ILT Training FSM Update

comments #463, 45, 230, 481

Figure 178B-1—ISL and Path

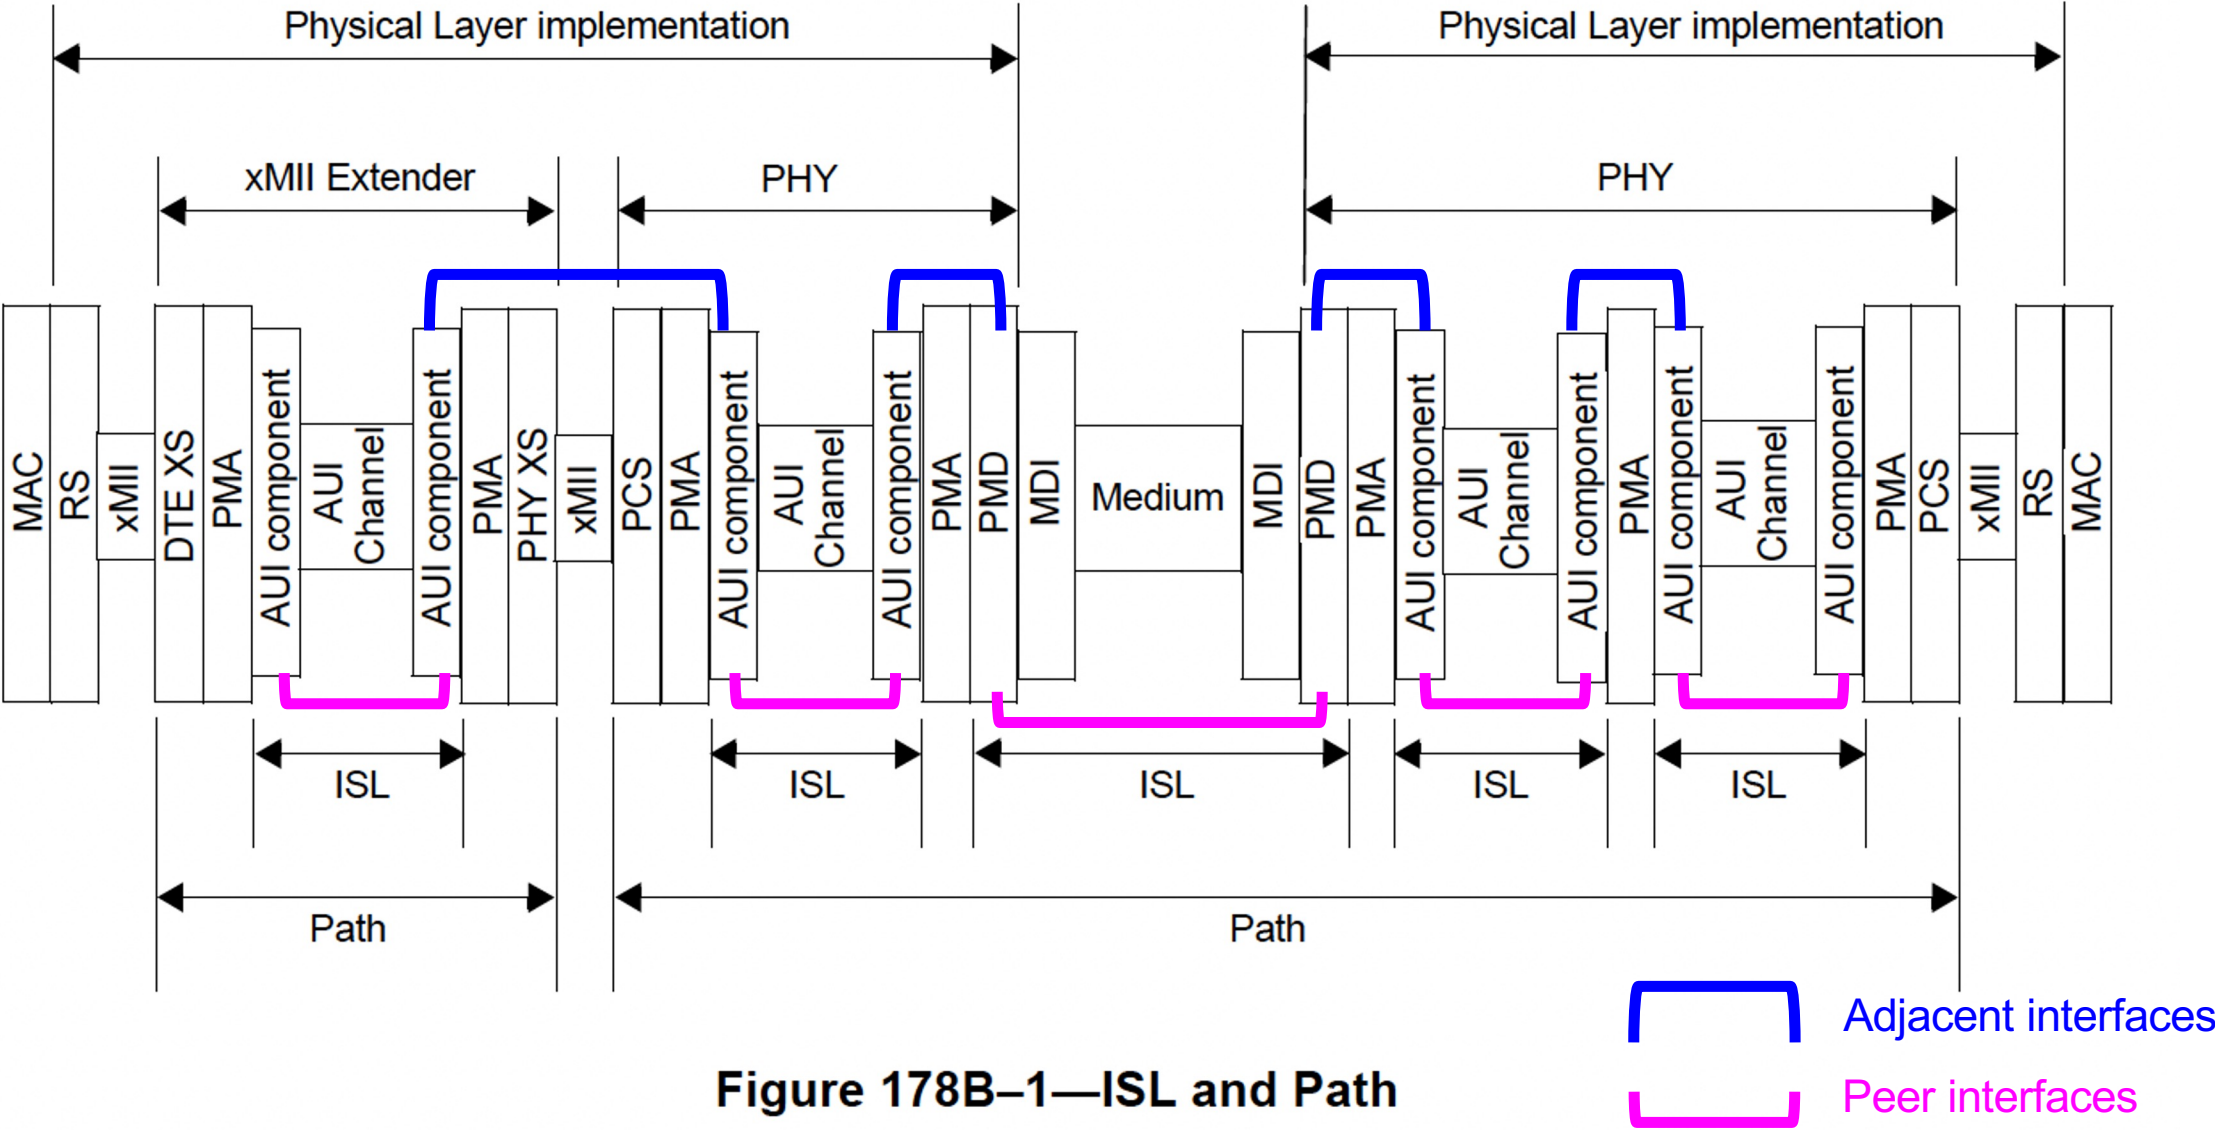
Add the following definition into 178B.3:

Interface whose service interface is connected (directly or indirectly) with this interface. There may be multiple sub-layers between the two ILT interfaces. For example, in Figure 178B-1 the first AUI component above (left) of the PHY_XS and the first AUI component below (right) of the PCS (for the Physical Layer on the left) are adjacent interfaces of each other.

Figure 178B-10—Training control state diagram

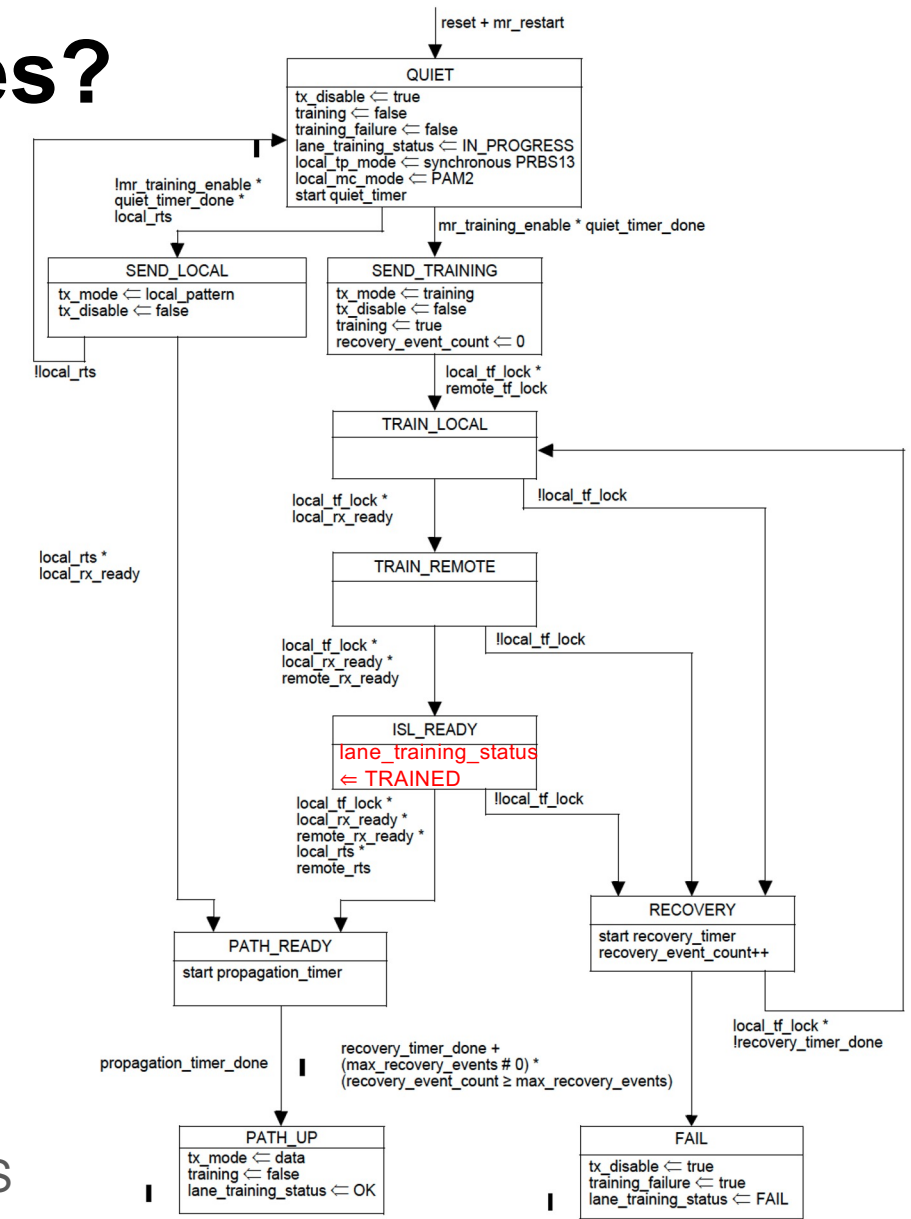
This assignment of the training_status variable needs to be removed from (Figure 178B-9) as that’s information to be sent to another interface, not used by the local interface.

Adj Rx done adapting: Add a new lane_training_status state of TRAINED that indicates local_rx_ready and remote_rx_ready are both true. This is used in training_status state generation which is mapped to SIGNAL_OK

SIGNAL_OK primitive is used to transfer the above states to the adjacent interface and is mapped from training_status variable. Define the states of training_status to be as follows:

FAIL: Any lane_training_status is FAIL

OK: All lane_training_status are OK

READY: remote_rts is true AND all lanes have lane_training_status of TRAINED or OK with at least one lane being TRAINED.

IN_PROGRESS: At least one lane has lane_training_status of IN_PROGRESS and no lanes have lane_training_status of FAIL.

Figure 178B-9—RTS update state diagram

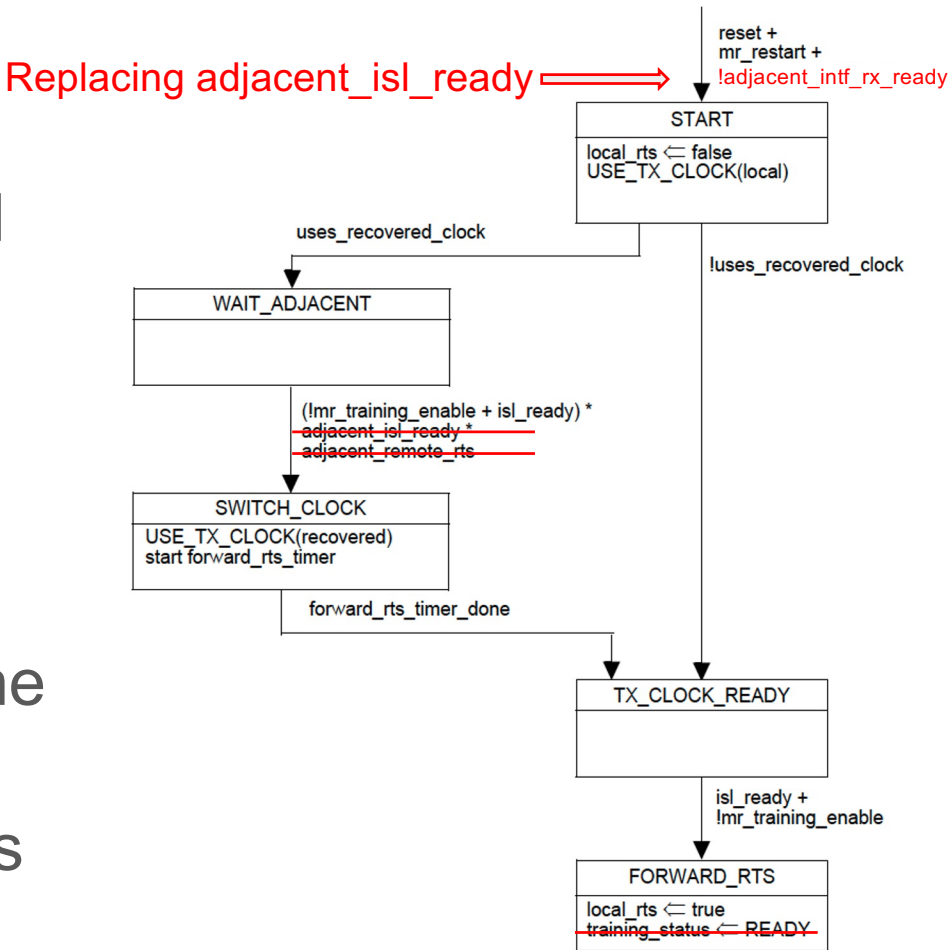
Make RTS update state diagram be just about the Tx

Remove adjacent_remote_rts and adjacent_isl_ready variables definitions and add adjacent_intf_rx_ready.

Boolean variable that is derived from the received SIGNAL_OK primitive on the service interface. It is set to TRUE when SIGNAL_OK is either READY or OK and FALSE otherwise.

Figure 178B-10—Training control state diagram

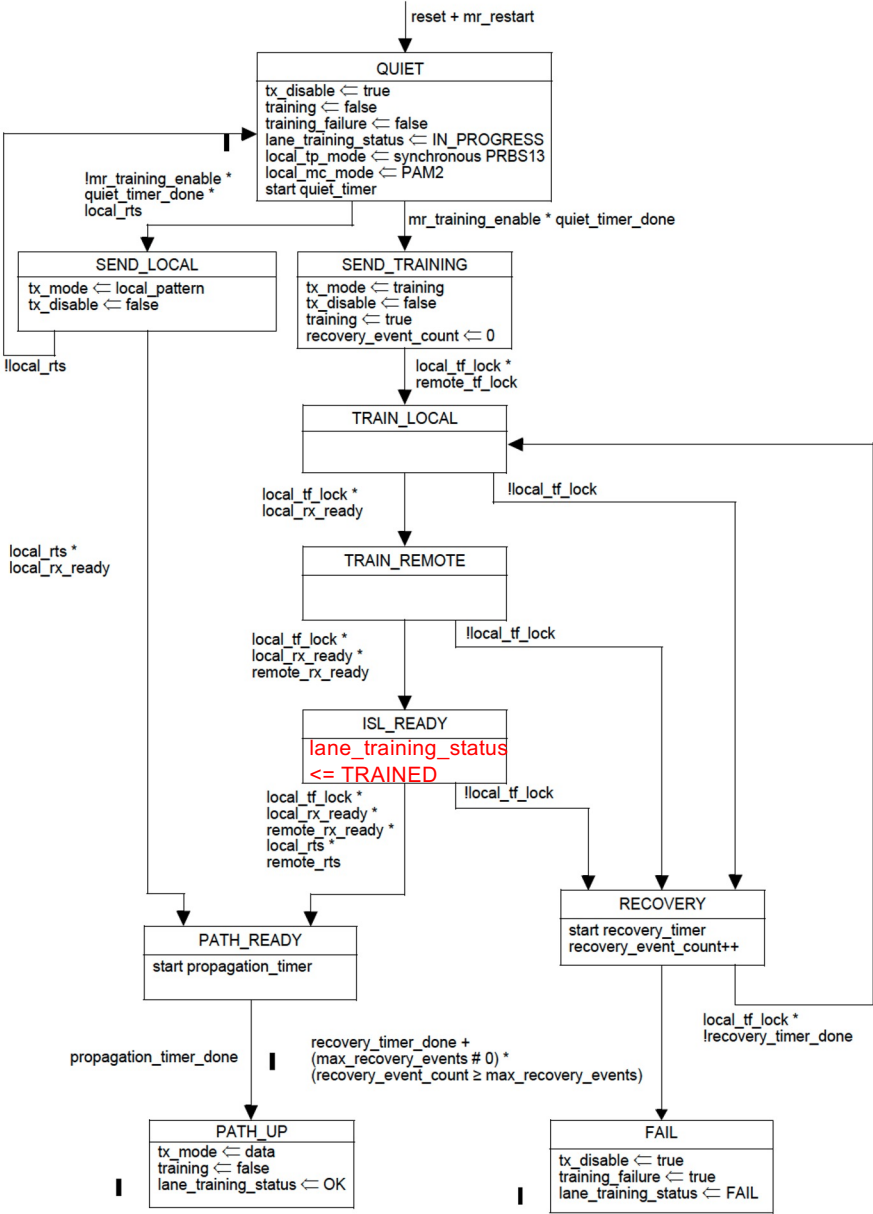
Changes to Figure 178B-10 highlighted in red.

Define the states of training_status in 178B.7.2.1 to be as follows:

FAIL: Any lane_training_status is FAIL

OK: All lane_training_status are OK

READY: remote_rts is true AND all lanes have lane_training_status of TRAINED or OK with at least one lane being TRAINED.

IN_PROGRESS: At least one lane has lane_training_status of IN_PROGRESS and no lanes have lane_training_status of FAIL.

Figure 178B-9—RTS update state diagram

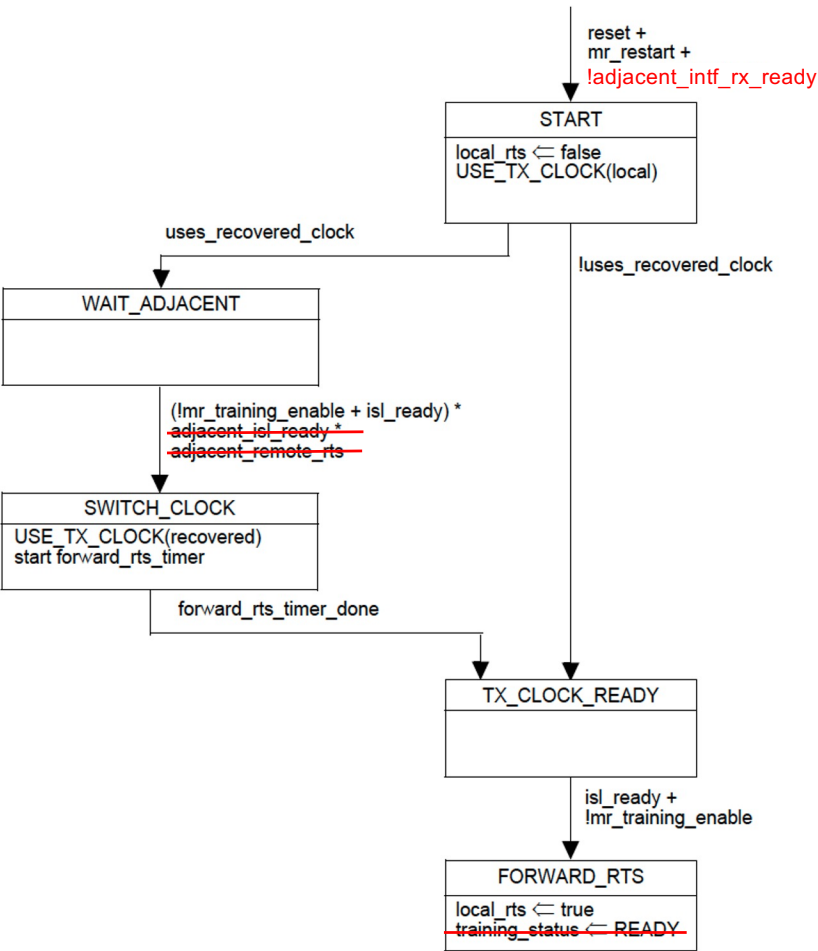
Changes to Figure 178B-9 indicated in red.

Remove adjacent_remote_rts and adjacent_isl_ready variables definitions and add adjacent_intf_rx_ready as follows:

Boolean variable that is derived from the received SIGNAL_OK primitive on the service interface. It is set to TRUE when SIGNAL_OK is either READY or OK and FALSE otherwise.

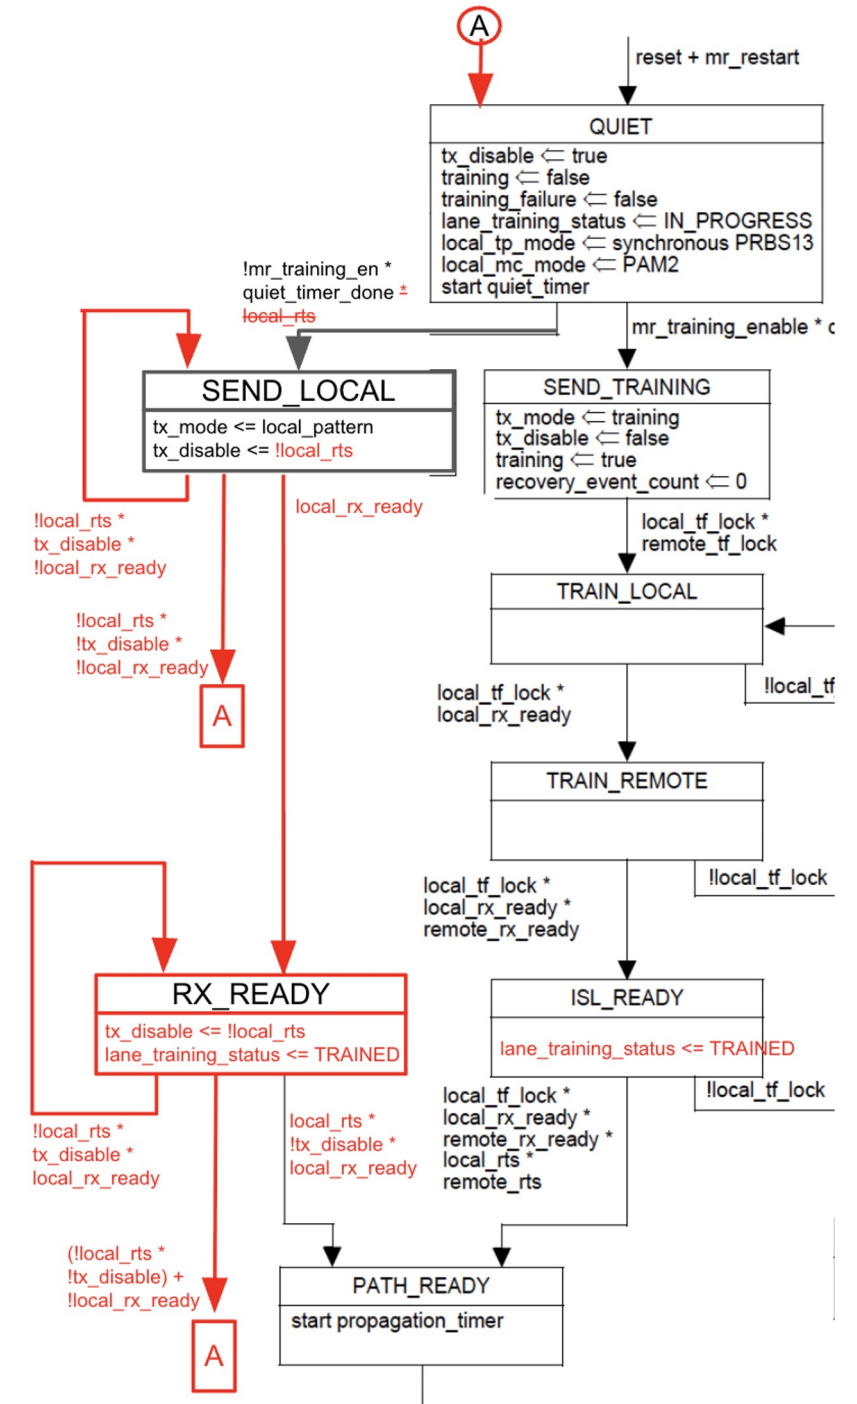
In local pattern mode Tx and Rx are disjoint - one can be ready while other is still “off”. The Tx needs to wait until it’s on mission clock (`local_rts = true` [item 1,2,3]) to begin transmitting, prior to peer Rx running adaptation. The Rx needs to adapt as soon as it sees data, and set `lane_training_status` to TRAINED when ready, which indicates the adjacent interface Tx may now swap to mission clock.

The following are the updates to Figure 178B-10 shown to right:

- Ensure Tx is squelched for at least the quiet timer duration. Then support either Tx or Rx completing first.
- Unsquelch Tx once its swapped to mission clock (`local_rts = true`)
- Set `lane_training_status` to TRAINED when Rx is ready
- Monitor if `local_rts` changes from true to false, go back to QUIET to squelch for a minimum period of time.
- Monitor if `local_rx_ready` changes from true to false, go back to QUIET to squelch for a minimum period of time.

Figure 178B-10—Training control state diagram

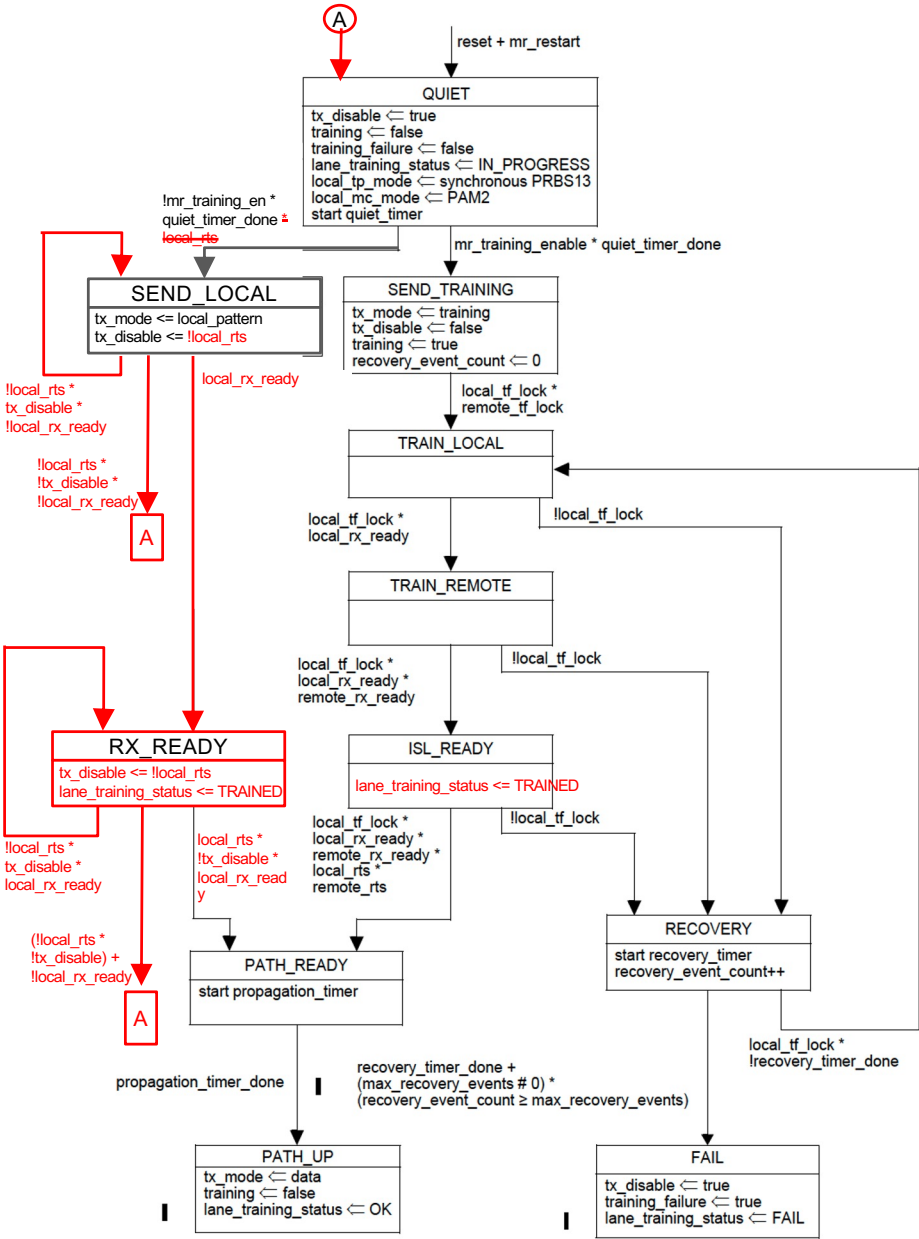
Changes to Figure 178B-10 highlighted in red.

Define the states of training_status in 178B.7.2.1 to be as follows:

- FAIL:** Any lane_training_status is FAIL
- OK:** All lane_training_status are OK
- READY:** remote_rts is true AND all lanes have lane_training_status of TRAINED or OK with at least one lane being TRAINED.
- IN_PROGRESS:** At least one lane has lane_training_status of IN_PROGRESS and no lanes have lane_training_status of FAIL.

Figure 178B-9—RTS update state diagram

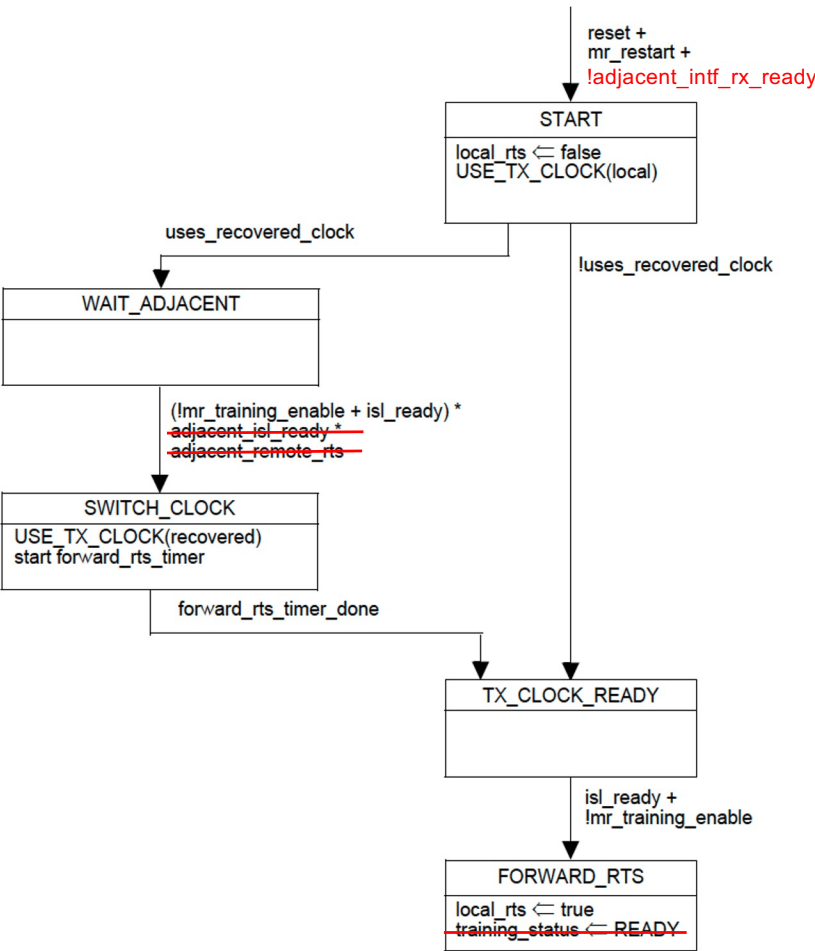
Changes to Figure 178B-9 indicated in red.

Remove adjacent_remote_rts and adjacent_isl_ready variables definitions and add adjacent_intf_rx_ready as follows:

Boolean variable that is derived from the received SIGNAL_OK primitive on the service interface. It is set to TRUE when SIGNAL_OK is either READY or OK and FALSE otherwise.
